Docket Number:	16-AFC-01
Project Title:	Stanton Energy Reliability Center
TN #:	225827
Document Title:	Errata to the PMPD
Description:	Errata to the Presiding Member's Proposed Decision
Filer:	Ken Celli
Organization:	Energy Commission Hearing Office
Submitter Role:	Committee
Submission Date:	11/6/2018 1:29:11 PM
Docketed Date:	11/6/2018

STANTON ENERGY RELIABILITY CENTER

Docket No. 16-AFC-01

ERRATA TO THE PRESIDING MEMBER’S PROPOSED DECISION

Socioeconomics Figure 2 – Boundaries Used to Identify Low Income Population

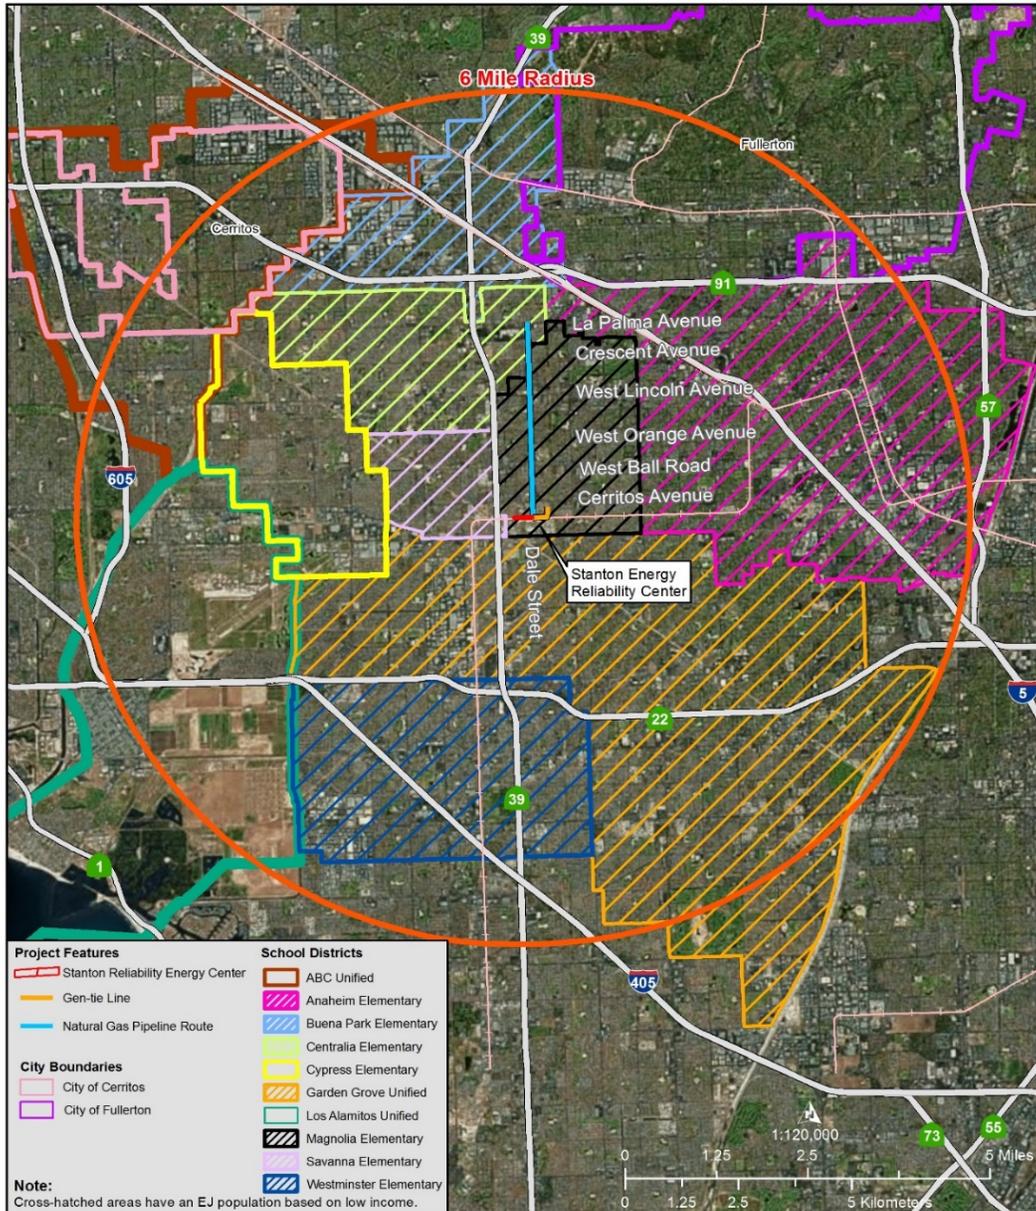
1. Page 8.3-4: insert the following header, map, and citation as Socioeconomics Figure 2, below.
